TOWNSHIP OF ABINGTON

(2) CODE ENFORCEMENT AND LAND DEVELOPMENT COMMITTEE

**CE1. Subdivision SD-15-01 - James Sheridan - 1777 Kimball
 Avenue**

CE2. *Land Development LD-15-02 – Molly Court Associates, LLC – 720 Rhoads Avenue*

BY: JOHN S. LUPTON
ABINGTON TOWNSHIP
MONTGOMERY COUNTY
PENNSYLVANIA
SCALE: 1" = 20' DATE: JANUARY 14, 2015 SHEET 1 OF 11

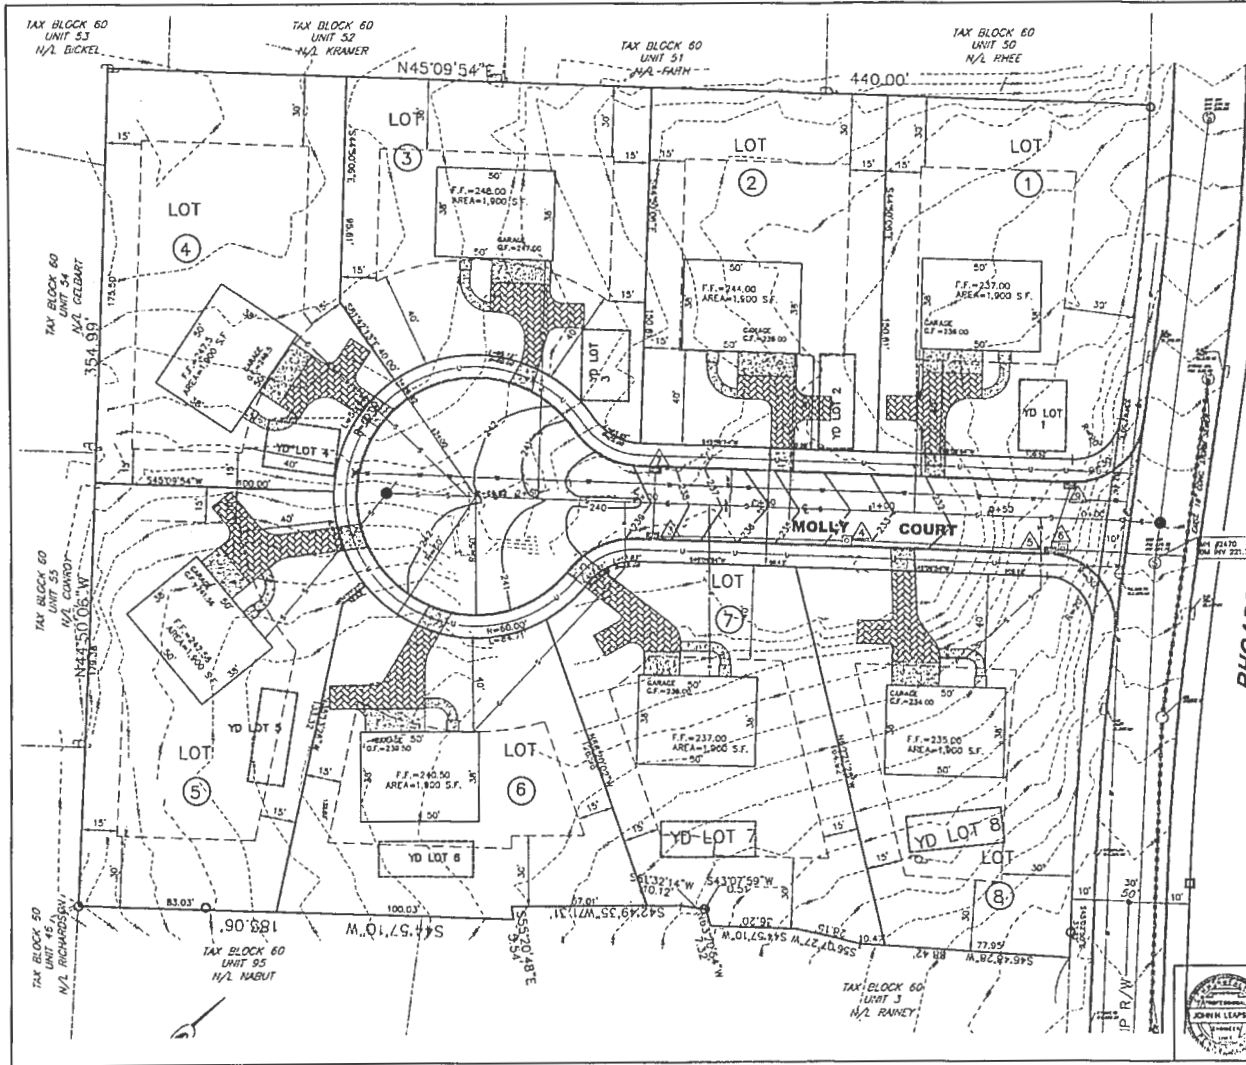
21. The plan plots the width of the roadway at 30 feet on sheet #1 and at 47 feet on sheet #4, #5, #9 and #10. Please revise the scale of those plans
22. This project will require seven (7) additional EDU's. They are available, and an ACT 537 Exemption Application has been submitted to DEP for approval. The application was reviewed and approved for sign-off by the Director of Waste Water Treatment Facility.
